For: The Commissioners
From: William J. Dircks
Executive Director for Operations
Subject: OCONEE UNIT NO. 3 - SPENT FUEL POOL EXPANSION

Subject: TROJAN NUCLEAR PLANT - SPENT FUEL POOL RERACK APPLICATION

The Commission has issued the enclosed Amendments Nos. 76 and 43 to Facility Operating Licenses Nos. DPR-51 and NPF-6 for Arkansas Nuclear One, Units Nos. 1 and 2 (ANO-1 & 2). These amendments consist of changes to the Technical Specifications in response to your application transmitted by letter dated November 5, 1982, supplemented by letters dated February 17, 1983, March 3, 7, 10, 21, 22, 24, 28 and 29, 1983, and April 5 and 7, 1983.

Figure 3.8.1

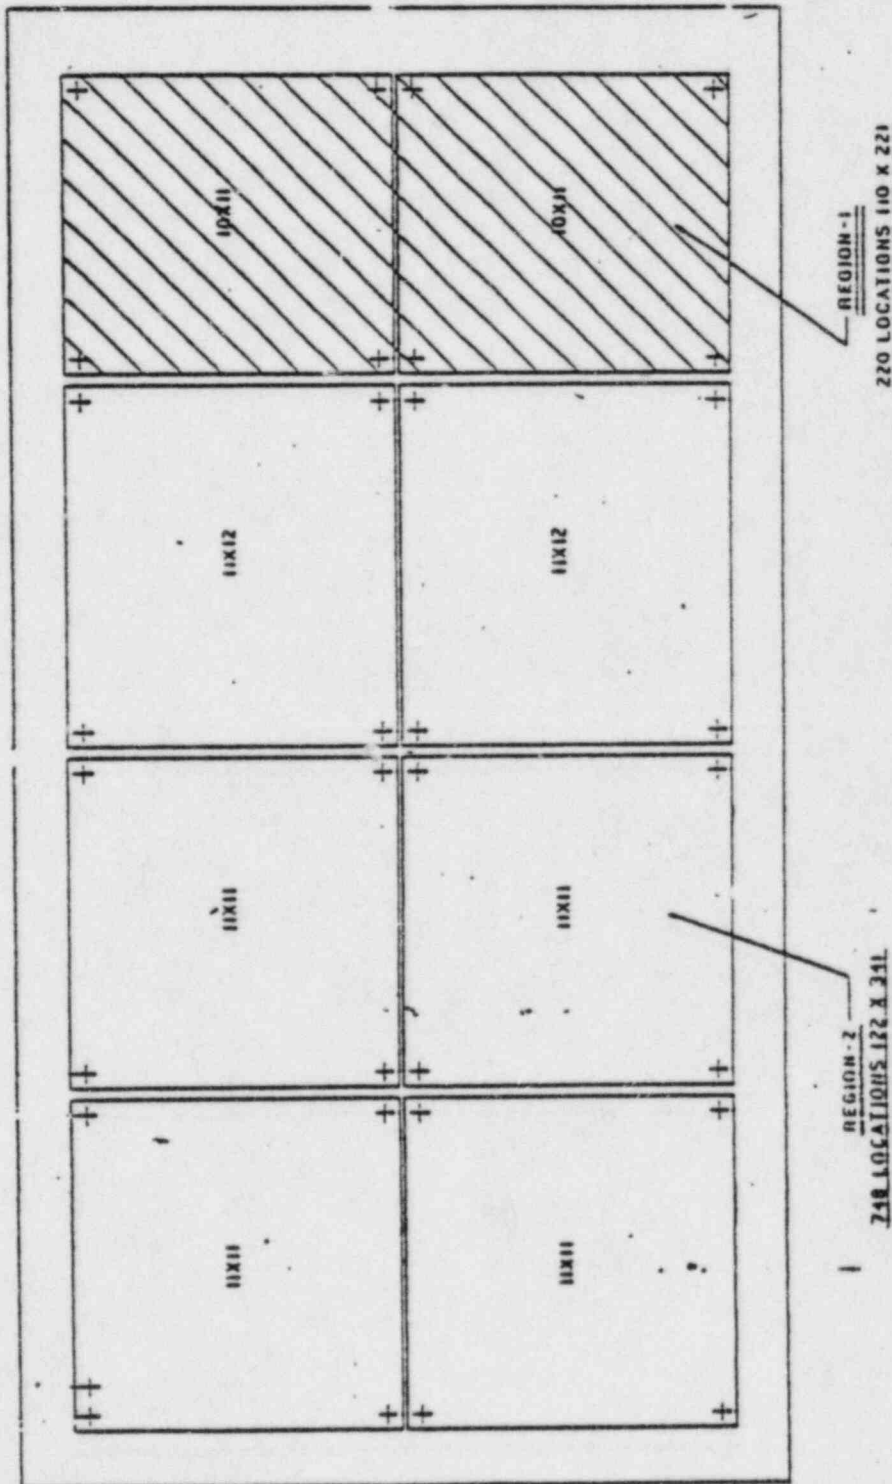
SLENT FUEL POOL ARRANGEMENT UNIT #1

FIGURE 3.8.2
MINIMUM BURNUP VS. INITIAL ENRICHMENT
FOR REGION 2 ENRICHMENT

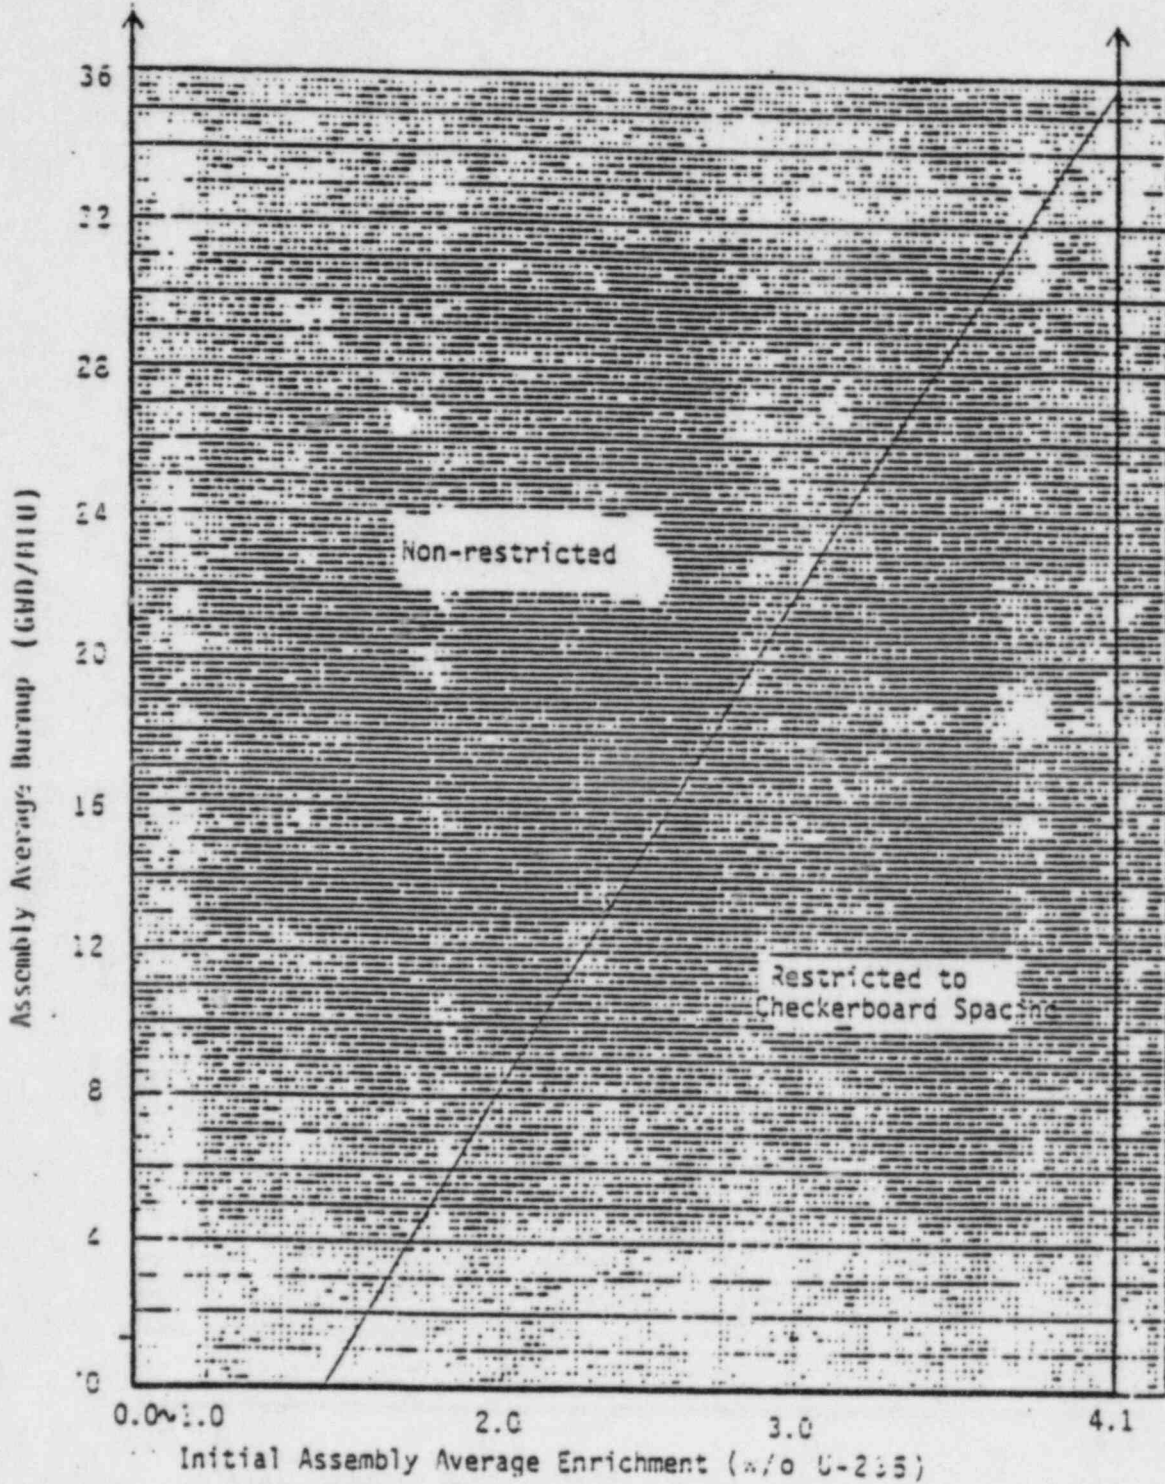
In order to establish burnup criteria for storage in Region 2 for each unit, a constant storage rack infinite multiplication factor (with minimum post-shutdown fission product inventory) contour is constructed as a function of burnup and initial enrichment using LEOPARD and TURTLE. ~~This contour~~ is based on a high enrichment endpoint of 4.10 weight percent and 36,000 MWD/MTU as shown in Figure 3.8.2 from the proposed ANO-1 TSs and in Figure 3.9.2 from the proposed ANO-2 TSs.

The final multiplication factors for Region 2 are determined using the same KENO IV method used for Region 1 with the conditions determined by the zero burnup intercept point in Figure 3.8.2 for ANO-1 and Figure 3.9.2 for ANO-2. In these cases, the intercept points are at 1.4 weight percent U-235. Therefore, the design mode for Region 2 for ANO-1 & 2 is an unirradiated assembly of 1.4 weight percent initial enrichment. LEOPARD and TURTLE are thus used only to calculate relative reactivities as a function of burnup while the KENO IV Monte Carlo method is used to determine the actual storage rack reactivity. The nominal case multiplication factors are calculated to be 0.8892 for ANO-1 and 0.9068 for ANO-2. Increasing these by the above calculated 95/95 uncertainty of 2.48 percent gives final Region 2 multiplication factors of 0.914 for ANO-1 and 0.9316 for ANO-2 which meet our acceptance criterion of less than or equal to 0.95. Based on our review, we conclude that any number of B&W design 15X15 fuel assemblies with burnups in the non-restricted region of Figure 3.8.2 may be stored in Region 2 of the ANO-1 spent fuel storage racks and that any number of CE design 16X16 fuel assemblies with burnups in the non-restricted region of Figure 3.9.2 may be stored in Region 2 of the ANO-2 spent fuel storage racks.

Figure 1.9.1

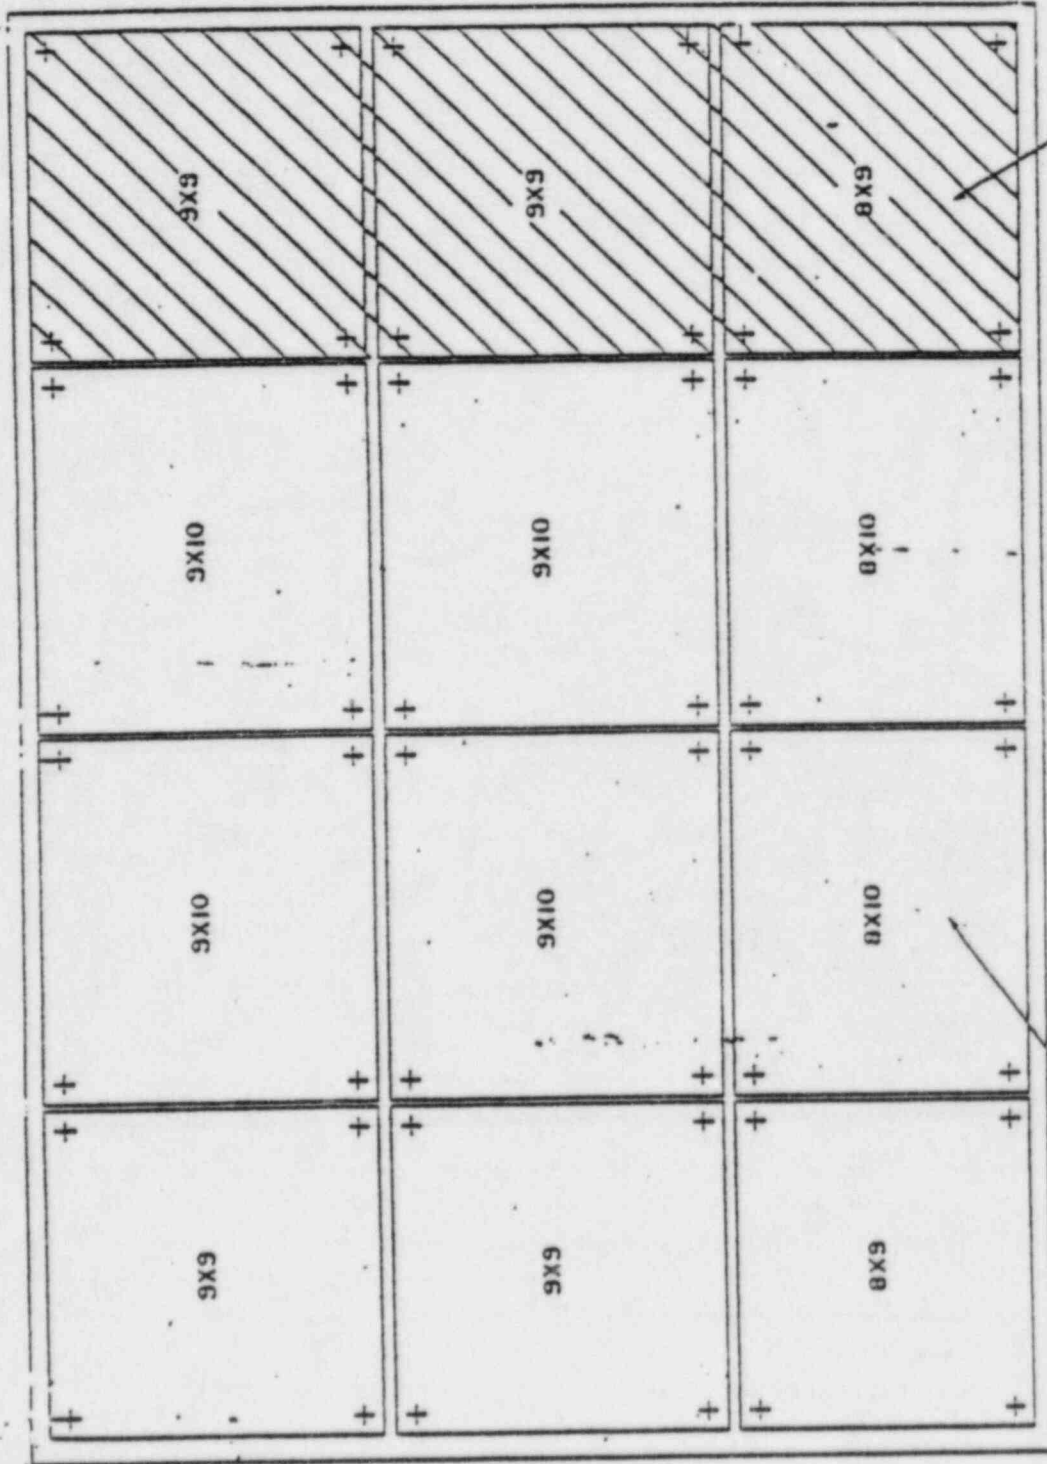
3.9.12.b Storage in Region 2 (as shown on Figure 3.9.1) of the spent fuel pool shall be further restricted by burnup and enrichment limits specified in Figure 3.9.2. In the event a checkerboard storage configuration is deemed necessary for a portion of Region 2, vacant spaces adjacent to the faces of any fuel assembly which does not meet the Region 2 burnup criteria (Non-Restricted) shall be physically blocked before any such fuel assembly may be placed in Region 2. This will prevent inadvertent fuel assembly insertion into two adjacent storage locations. The provisions of Specification 3.0.3 are not applicable.

FIGURE 3.9.2

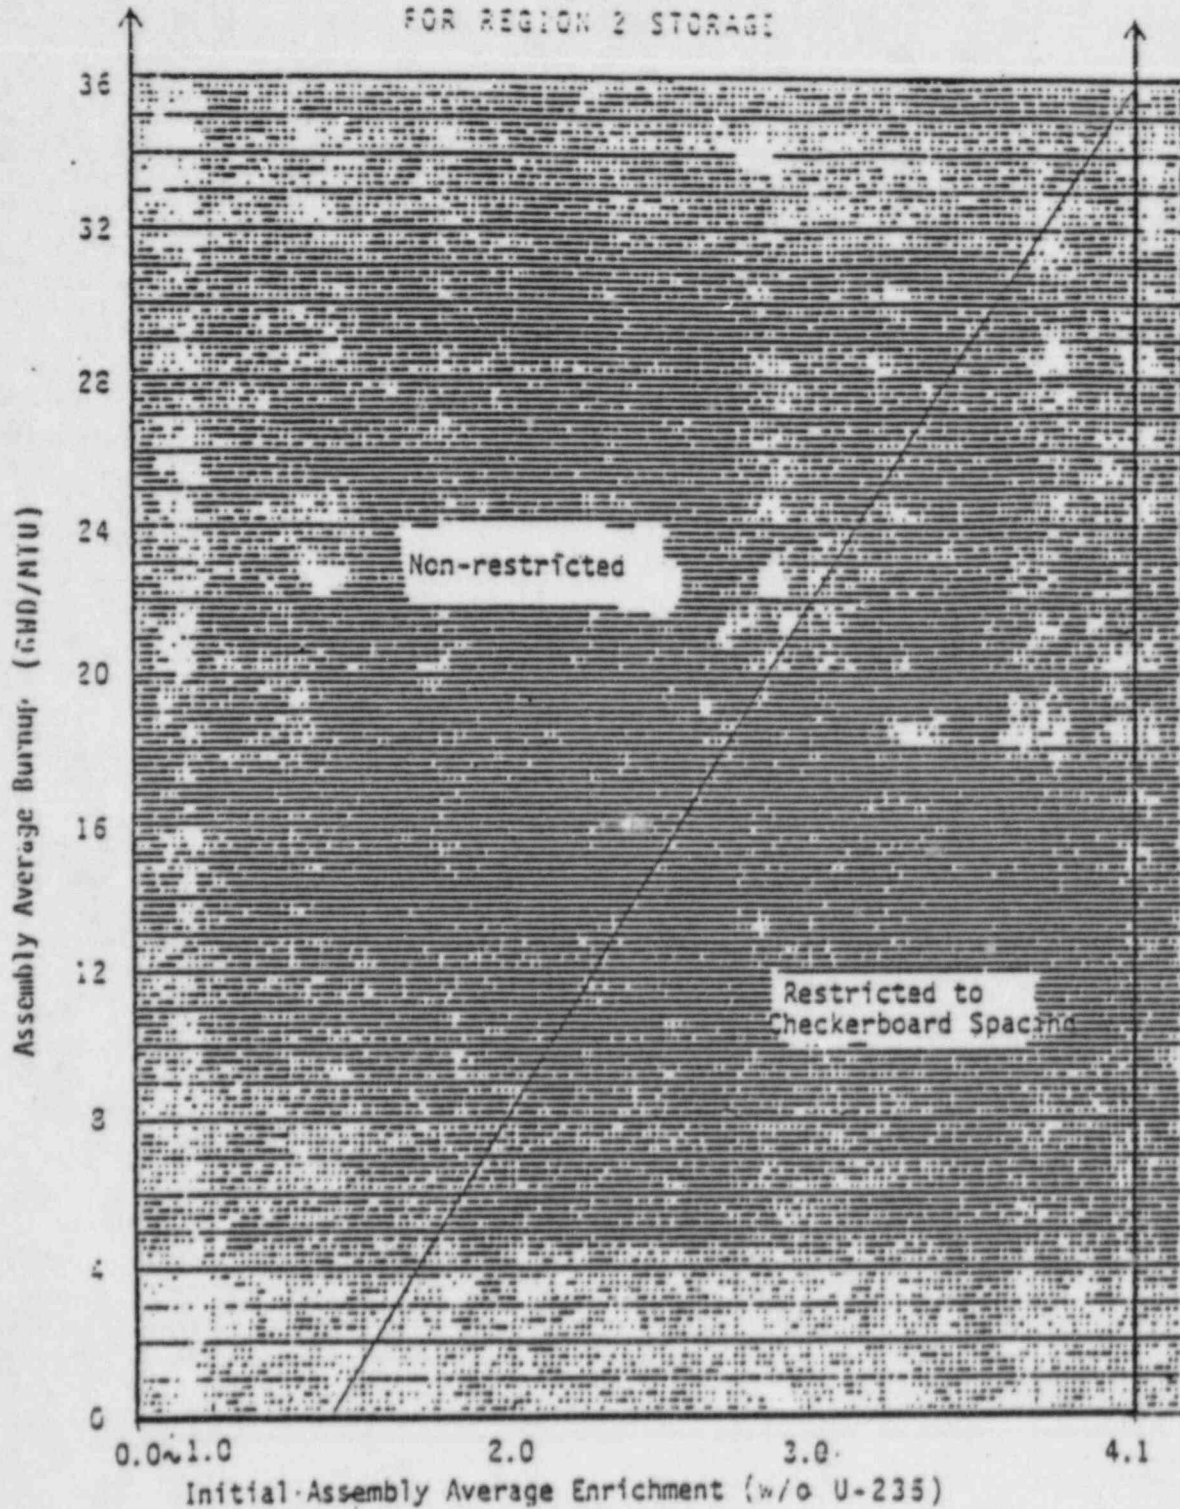
4.9.12.b Verify all fuel assemblies to be placed in Region 2 of the spent fuel pool are within the enrichment and burnup limits of Figure 3.9.2 by checking the assemblies design and burnup documentation.

Region 2 of the spent fuel storage racks is designed to assure fuel assemblies within the burnup and initial enrichment limits of Figure 3.9.2 will be maintained in a subcritical array with $K_{eff} \leq 0.95$ in unborated water. These conditions have been verified by criticality analyses.
